1.0 APPLICATION DETAILS

Ref: 21/03703/FUL
 Location: 18 Rectory Park, South Croydon CR2 9JN
 Ward: Sanderstead
 Description: Demolition of existing property and construction of a block of 5 flats plus 3 houses with associated access, car parking and landscaping (amended description).
 Drawing Nos: 920:1151/PL101D; 102A; 103A; 104A; 105A; 106; 107A; S20/7928/01
 Agent: N/A
 Applicant: Mr James Caldwell, Turnbull Land Ltd
 Case Officer: Yvette Ralston

Extract from Suburban Design Guide SPD (surrounding buildings 2 storey detached)

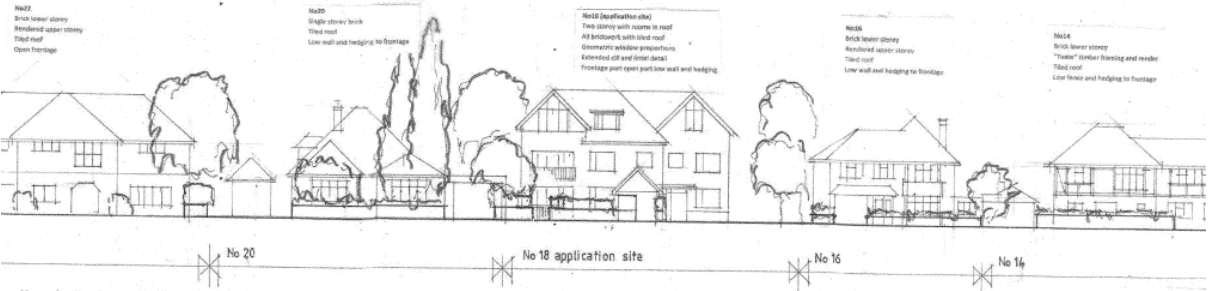
8.13 Properties along the street are generally separated by single storey garages. The existing property on the application site has a wide frontage at ground floor level of over 20m in total including the single storey, pitched roof side projections on either side. The proposed building at the front has a reduced width of 16m. The spaciousness on the site that is characteristic of the area is retained in the proposed scheme; the separation distance to number 16 would 7.8m across the access road. The building mass would be closer to number 20 than the existing situation as there would no longer be single storey side projection on this side, however the separation distance would be 5.8m (not including the garage of number 20) which is generous. The building is considered to sit comfortably within the street scene and to comply with the Suburban Design Guide.
